Dean Moor Solar Farm

Environmental Statement: Appendix 7.8 – Arboricultural Impact Assessment

26 August 2025
Prepared by: Stantec UK Ltd
PINS Ref: EN010155
Document Ref: D2.17
Deadline: 2
Revision: 2

Table 1.1: Revisions to Appendices B and C of the AIA

Rev: A

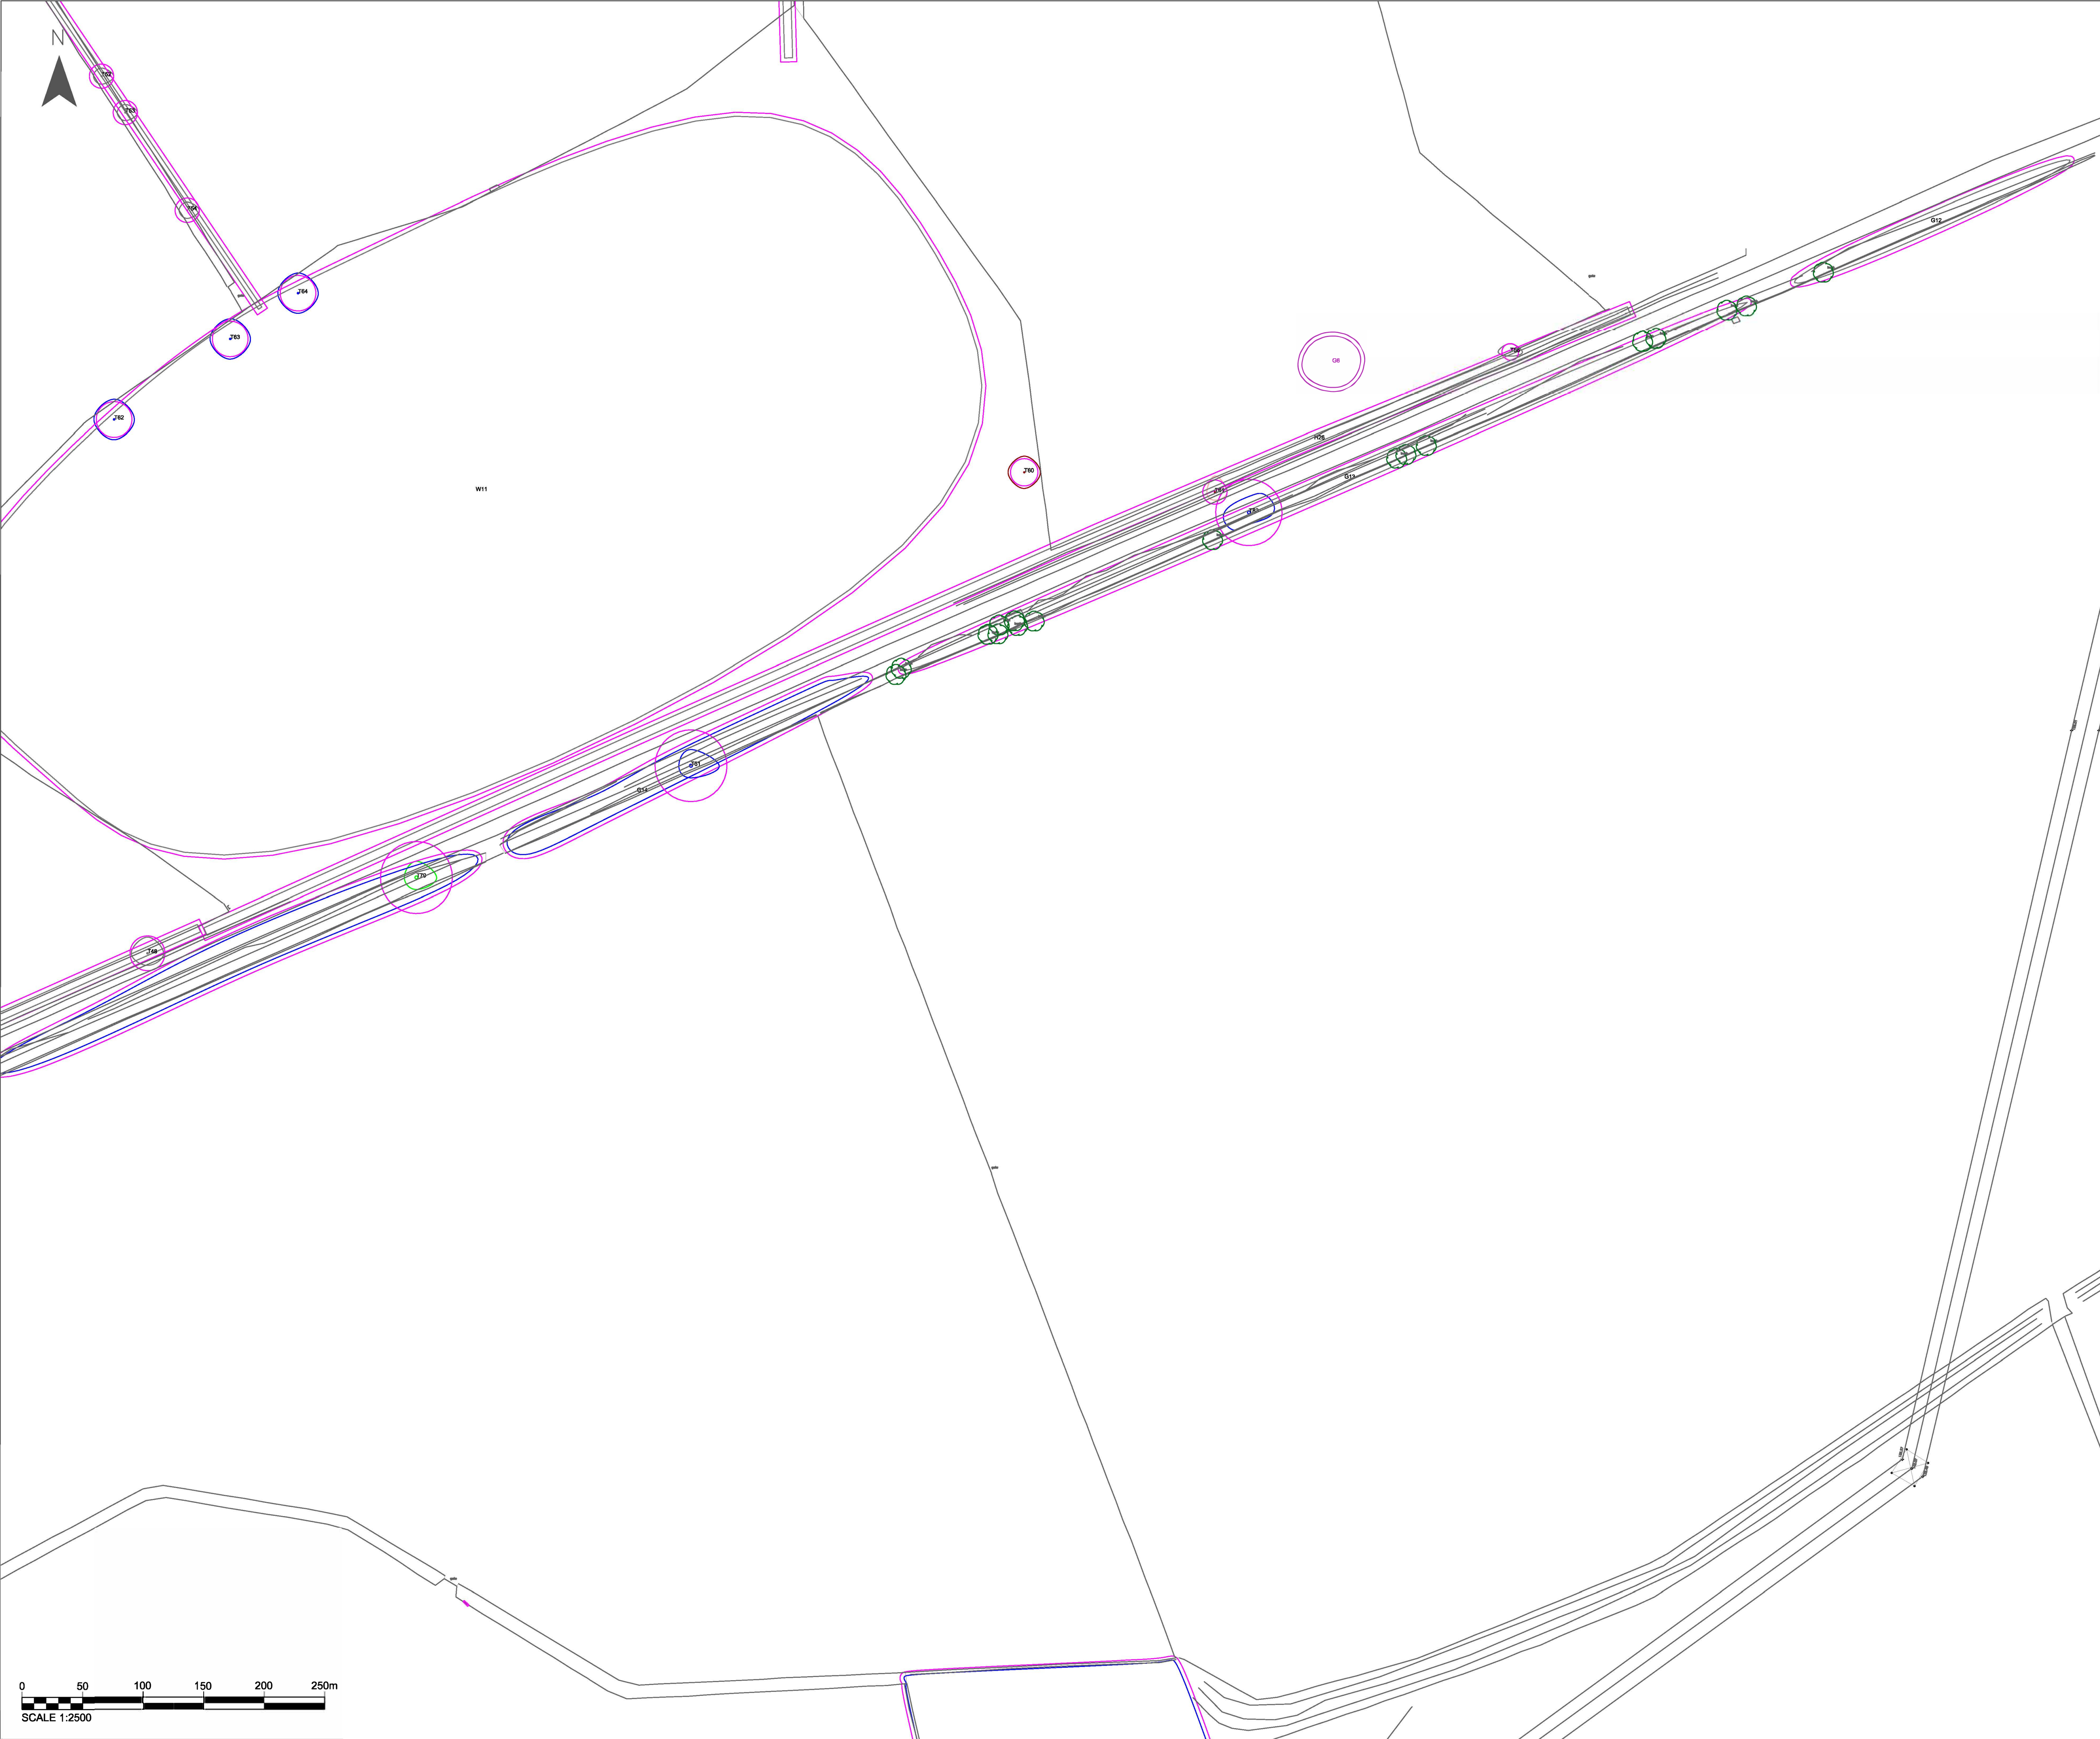
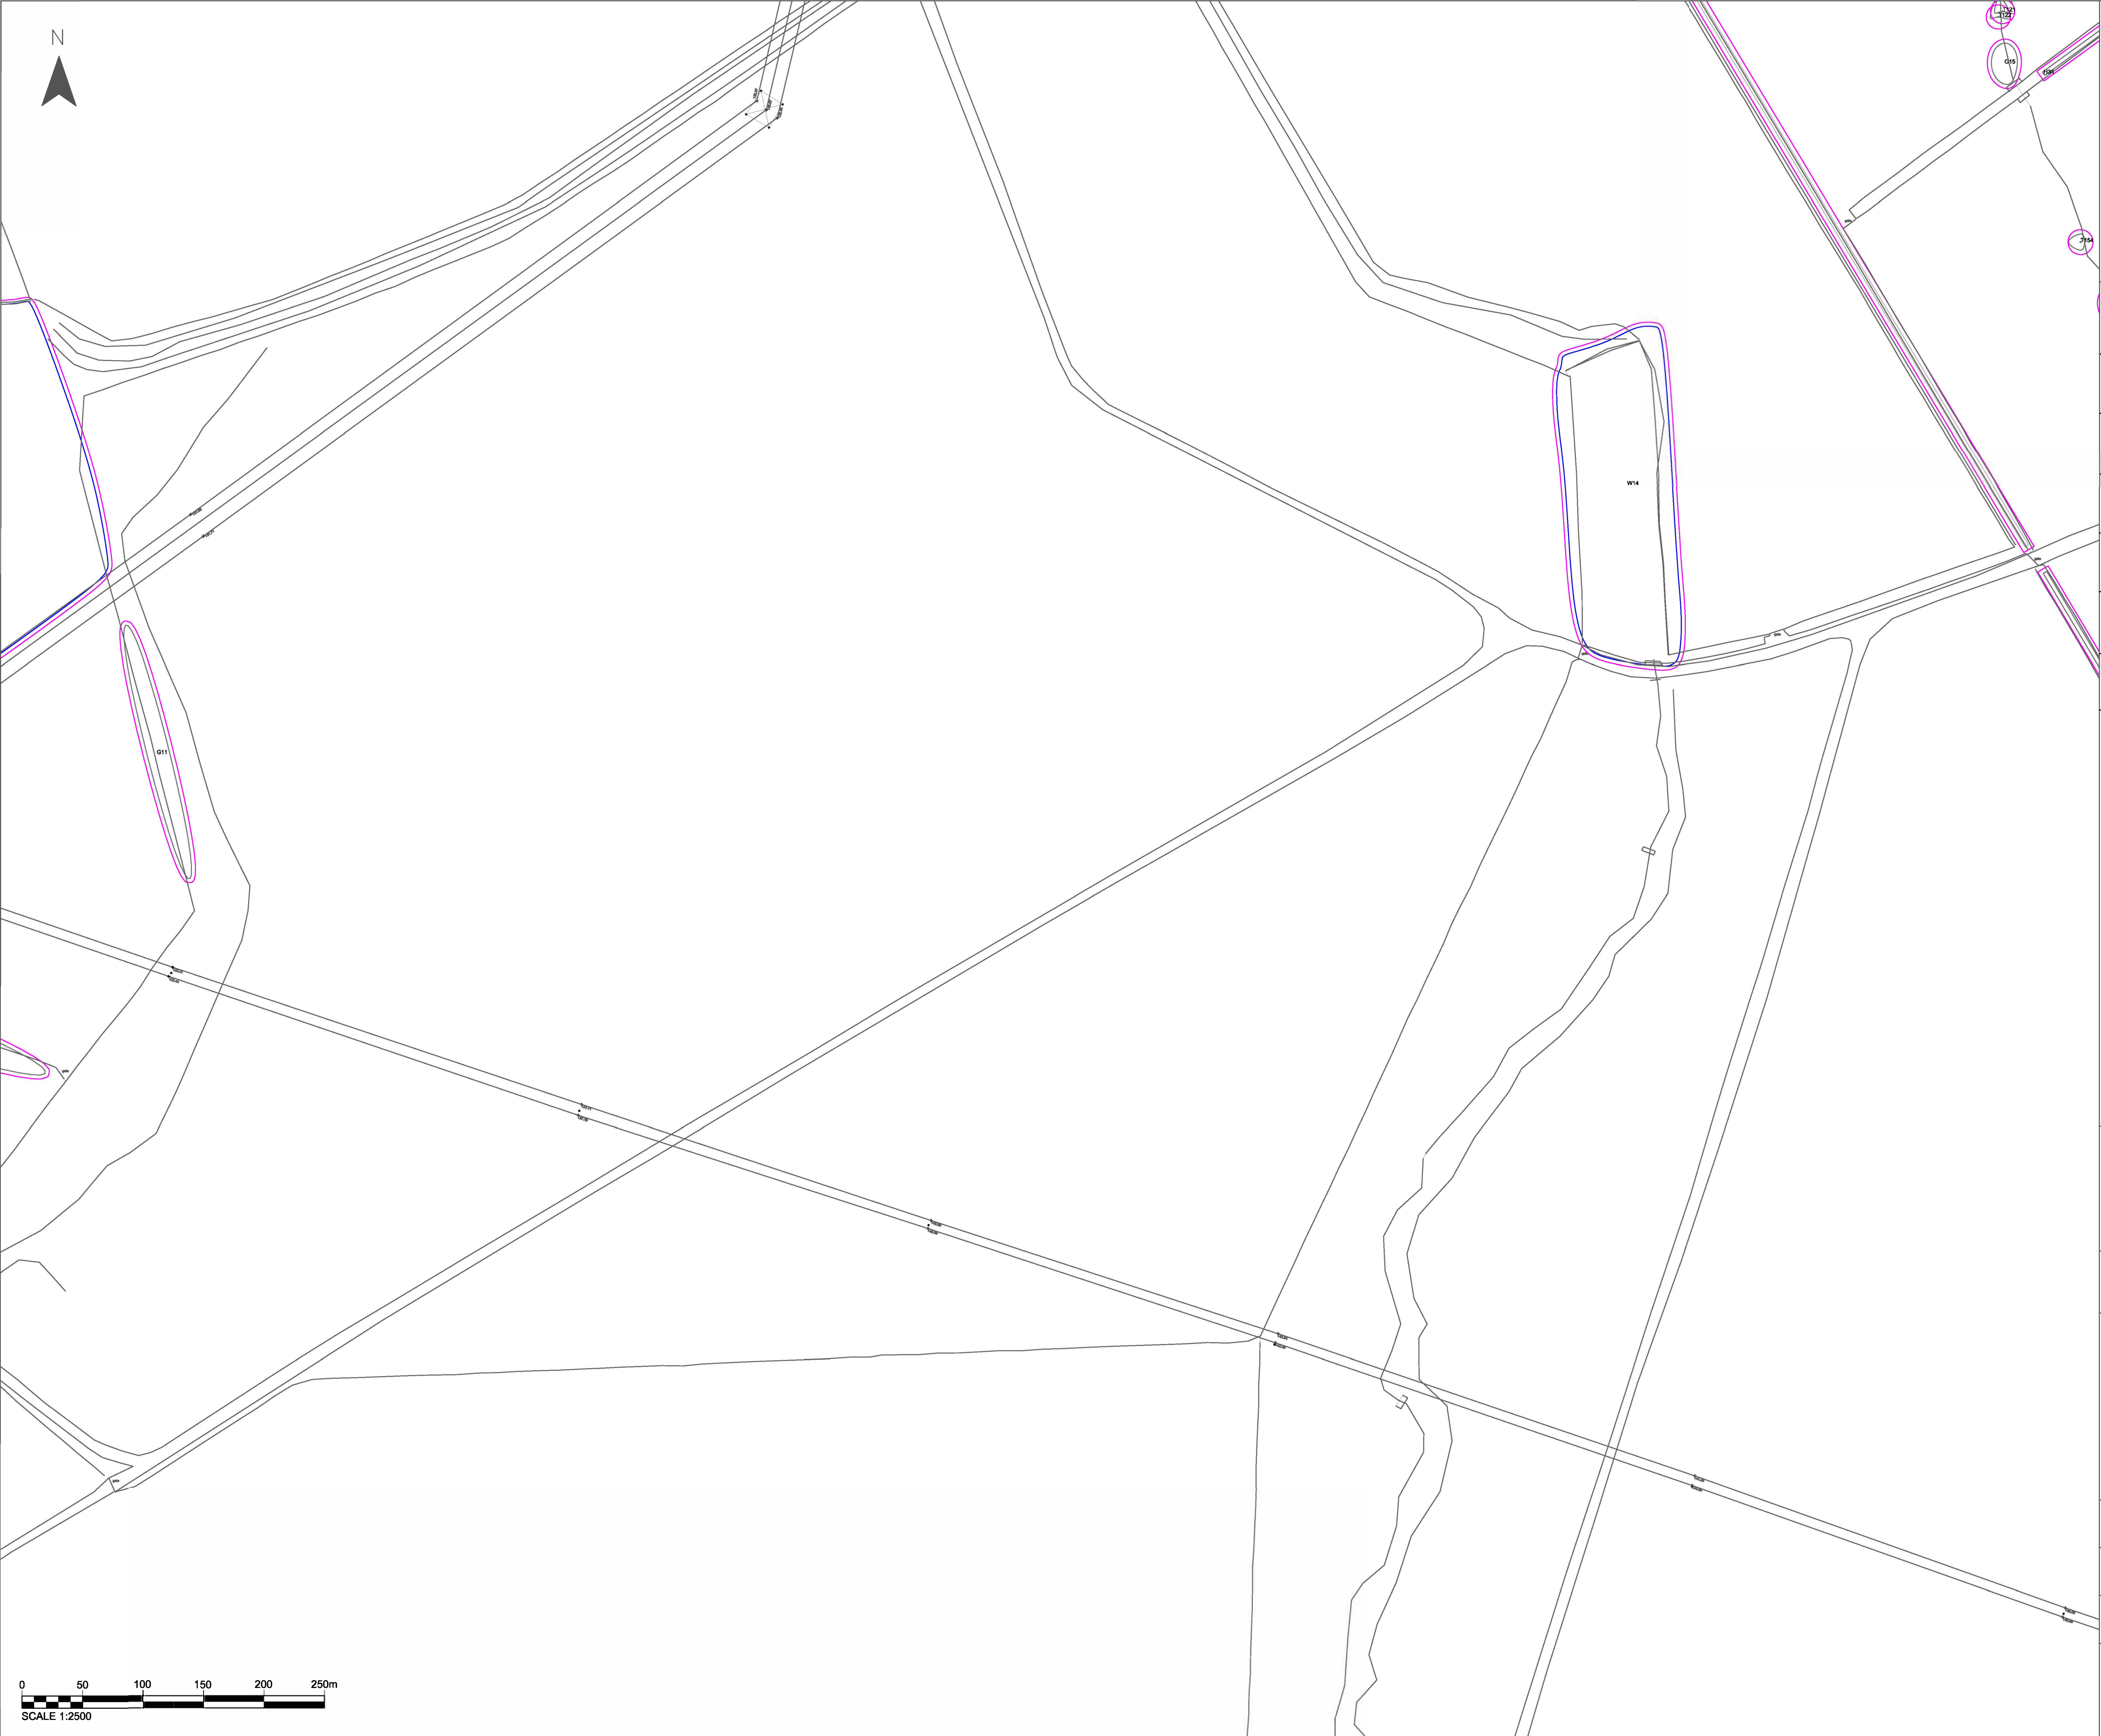
Revision	Reason
Change of the plan title in the TCP from 'Location Plan' to 'Tree Constraints Plan'	To make it clear that the plan is displaying the TCP. As the Location Plan is a different figure within the ES.
A renumbering of the sheets included in the TCP. Changing the order from 0-22 to 1-23.	To enable the first sheet within the TCP is numbered 1 rather than 0.
Change of the plan title in the TPP from 'Location Plan' to 'Tree Protection Plan'	To make it clear that the plan is displaying the TPP. As the Location Plan is a different figure within the ES.
A renumbering of the sheets included in the TPP. Changing the order from 0-22 to 1-23.	To enable the first sheet within the TPP is numbered 1 rather than 0.
